Access Compliance Report

Public Rights-of-Way

(Curb Ramps)

Intersection ID: 13916	Main Street: CLANTON_RD	Cross Street: WEST_BV	Location: SE
ADA ID: 3DC7E2C14FD1	Ramp Type: Perp	Initial Pass/Fail: Fail	Overall Compliance: No
Severity Score: 26.25			
Codes/Mitigation Info/Possible Solution		Field Measurements/Component Compliance

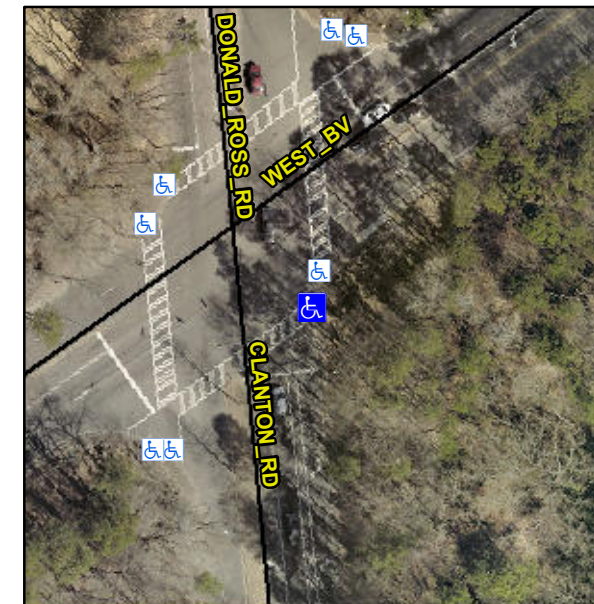
R304.2.2, R304.5.3

Compliance	Description	Data	Compliance	Description	Data
N/A	Ramp Length (in)	60.0	No	Ramp Slope (%)	13.2
Yes	Ramp Width (in)	60.0	No	Ramp XSlope (%)	4.0
N/A	Flare Type LT	N/A	N/A	Flare Type RT	N/A
N/A	Flare Slope LT (%)	N/A	N/A	Flare Slope RT (%)	N/A
N/A	Flare Traversable LT?	N/A	N/A	Flare Traversable RT?	N/A
N/A	Landing Length (in)	N/A	N/A	DWS Provided?	N/A
N/A	Landing Width (in)	N/A	N/A	DWS Contrast?	N/A
N/A	Landing Slope (%)	N/A	N/A	DWS Length (in)	N/A
N/A	Landing X Slope (%)	N/A	N/A	DWS Full Width?	N/A
N/A	Landing Curb? (Y/N)	N/A	N/A	DWS Offset (in)	N/A
N/A	Shared Landing?	N/A			
N/A	Gutter Ponding?	N/A	N/A	Gutter Slope (%)	N/A
N/A	Gutter Lip Ht (in)	N/A	N/A	Gutter X Slope (%)	N/A
N/A	Painted X Walk1?	Yes	N/A	Painted X Walk2?	N/A
	X Walk 1 Direction	To W		X Walk 2 Direction	N/A
N/A	X Walk 1 Width (in)	90.0	N/A	X Walk 2 Width (in)	N/A
	X Walk 1 Slope (%)	1.4		X Walk 2 Slope (%)	N/A
	X Walk 1 X Slope (%)	3.5		X Walk 2 X Slope (%)	N/A

Remove & Replace Entire Ramp.
